STAFF RECOMMENDATION

NCPC File No. 6712

**UNITED STATES DEPARTMENT OF HOMELAND SECURITY
NATIONAL CAPITAL REGION RAIL PILOT PROJECT
Washington, D.C.**

October 26, 2006

**SIMULATED VIEW OF THE ONLY SMALL
STRUCTURE ESTABLISHED IN THE PROJECT
DESIGN — 12 FT. x 20 FT. CONCRETE SHED**

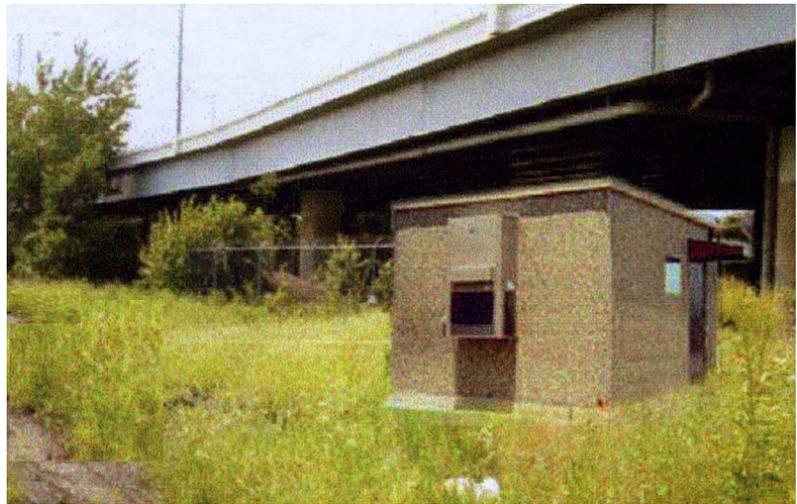
As far as the specifics of the NCRPP proposal are concerned, I do not see any significant problem with the housing in 12' x 12' x 7' metal structures at either end of the rail corridor of equipment to process incoming data from the "virtual gates" that would be installed. Similarly, the proposed use of approximately 200 fixed cameras mounted on 40-foot utility poles at 750-foot intervals and 30 pan/tilt/zoom cameras mounted at 1,500-foot intervals does not appear to be a concern, as long as these cameras are located in close proximity to the rail corridor and not in residents' neighborhoods. Lastly, the proposed use of high intensity lights mounted on 40-foot utility poles at 150 foot intervals also does not appear to pose a problem as long as these lights are also located along the rail corridor and do not disturb residents in their homes and neighborhoods.

Staff has found that DHS representatives have consciously and professionally worked with Commission of Fine Arts staff and NCPC staff in addressing visual design issues of the proposal. Furthermore, DHS has revised the project to incorporate National Park Service comments regarding the visual impact issues to the George Washington Memorial Parkway in Virginia and the Monumental Core. DHS responded by eliminating the Parkway portion of the project, and placing the most visually prominent aerial wires of the project underground within East Potomac Park and near Anacostia Park. Additionally, all equipment in the Monumental Core is established in dark colors where technically feasible and is minimized in composition and location. Only one small head-end electronic equipment shed is sited in the revised design and is limited in size to 240 square feet.
